West Nassau Landfill - Final Closure <sup>2012 AUG 30 AM 10: 15</sup>  
Contract No. CM1734 (Bid No. NC11-004)

**ALLOWANCE AUTHORIZATION**  
**(Line Item #4)**

Issued by: Golder Associates Inc.  
To: Comanco Environmental Corporation  
Allowance Authorization No.: 15  
Date: 7/13/2012

**RE: WEST NASSAU LANDFILL CLOSURE 1 – Allowance Request #15– Additional Installed GFFR Quantities**

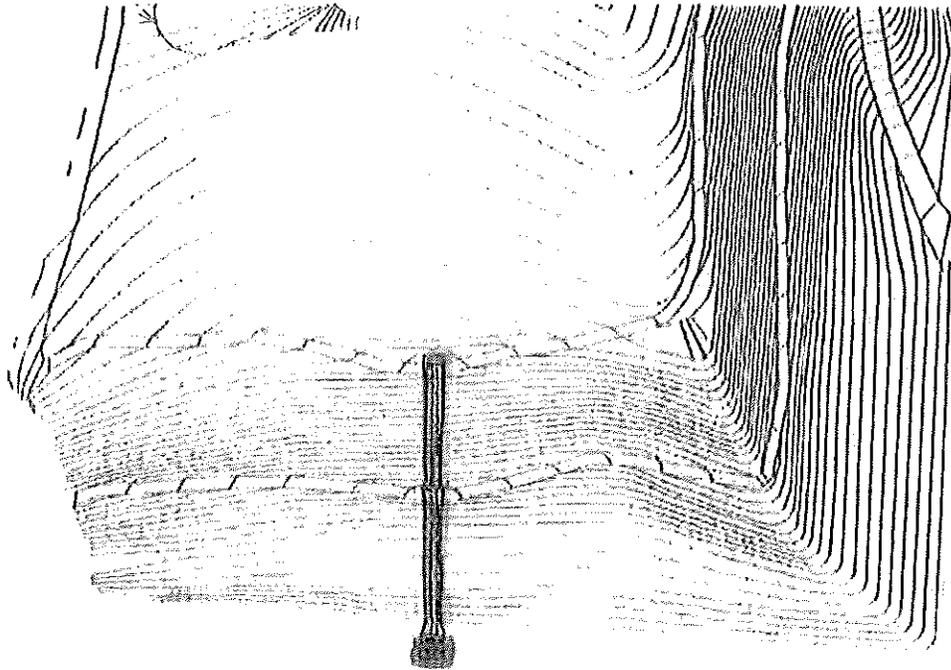
COMANCO over-ran the contract value of Bid Item 12B: 6' Wide GFFR Downslope Channel and Bid Item 13: GFFR Blanket Installation. Below is a breakdown for each item:

This item includes the South and East Downslope channels. We were contracted to install 614 LF and our survey of the actual installed quantity shows 675 LF – a 61 LF surplus. For both of these channels, our take-off was to the limits of construction which was at the bottom of the slope. This did not include the flat zone between the slope and the ditch. We actually constructed the channel across the flat area at the bottom of the slope and terminated at the crest of the ditch where it is then considered GFFR blanket. Also, at the top, we had it stopping at the top of the berm, but it actually went past that berm creating a bowl at the top and then a few more feet back and to the anchor trench. This created additional LF on top and bottom. The East channel was also re-designed to flow Northeast in lieu of straight East creating additional LF. The contract value for these items is \$110 / LF so we are requesting an additional **\$6,710** (61 LF x \$110 / LF) for this item.

This item includes the ditch areas, "Blankets", at the end of the South and East Downslope Channels. Our total square foot (SF) estimate for this item was 2,038 SF (1,094 SF + 944 SF) and our survey of the installed actual quantity was 2,283 SF (1,236 SF + 1,047 SF), roughly a 12% increase. On the original drawings, these areas were not very clear to the limits. We performed the best take-off we could with the blankets outlined in the drawings at the time of bid. In addition, the East blanket was re-designed and made larger by the time of installation. The contract value of this item is \$18,000 so we are requesting an additional **\$2,160** (\$18,000 x 12%) for this item.

We have enclosed the original estimate showing our original quantities as well as an illustration showing the discrepancies of the estimated quantities vs actual installed quantities. We have also attached our survey data showing the actual LF of downslope channels and actual SF of blankets for your reference.

File: Downslope Fabriform JS 4-4-12.esw

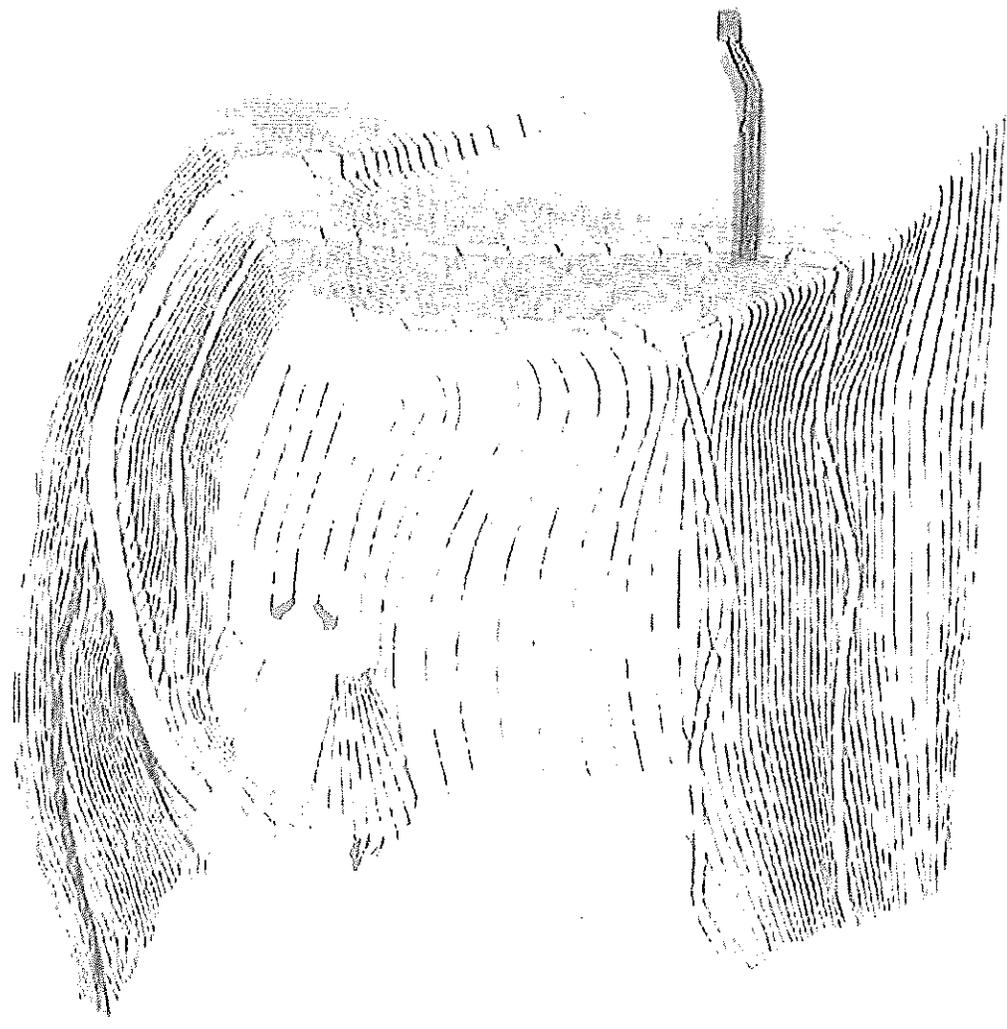
2 ft Toedown = 2 LF x 787 LF = 1,634 SF

2 ft Toedown = 2 LF x 101 LF = 202 SF

Ditch length

369 LF

$$= 785/2 - 15'$$

Per our conversation this afternoon, the "Wing" called out on the page 3 represents the areas where the downslope channels flare out on the lower berm and the Line Length called out Page 4 & 5 represents the perimeter length of the downslope channels. Please let me know if there are any more questions.

07114592 Nassau  
 File: East Downslope Fabriform JS 4-19-12.esw

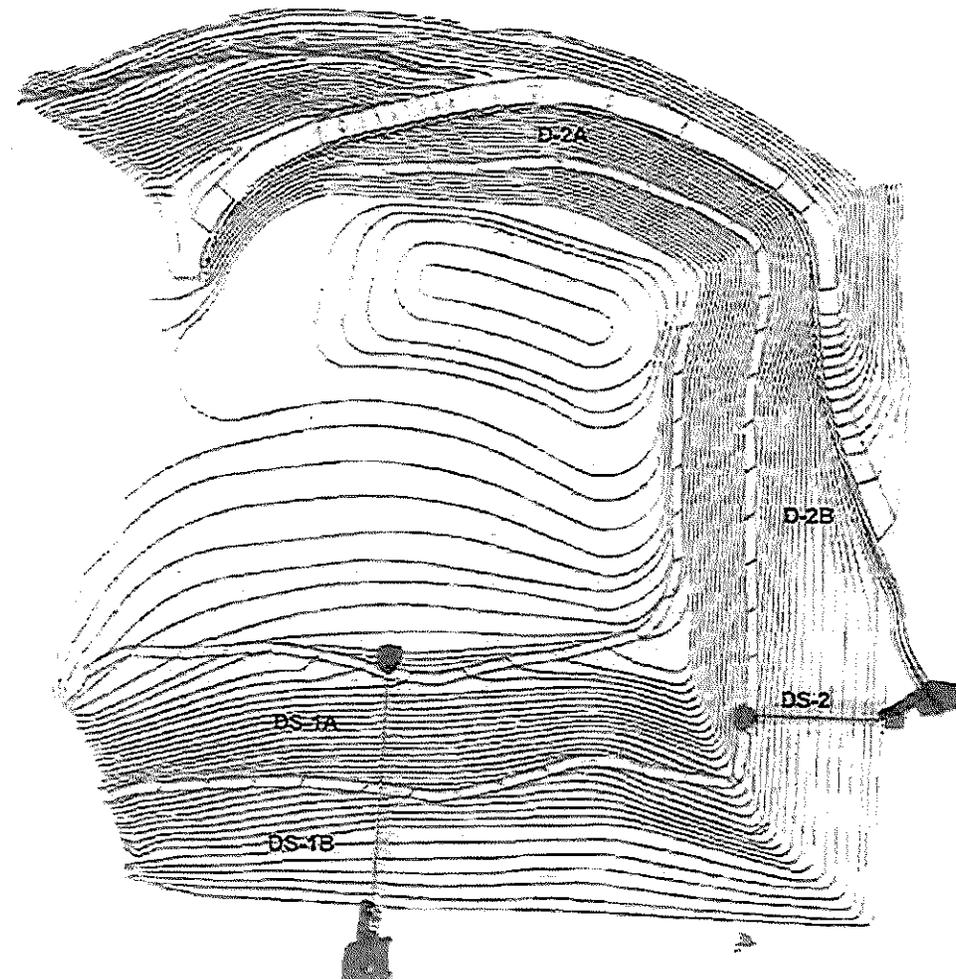
1x1 AT = 2 LF x 638 LF = 1,278 SF

REC  
 Ditch length  
 365 LF =  $649/2 - 15$

1x1 AT = 2 LF x 118 LF = 236 SF

6' DS CHANNEL  
 $369' + 306' = 675' \text{ Total}$

Blankets  
 $1,136 \text{ SF} + 1,047 \text{ SF} = 2,183 \text{ SF Total}$
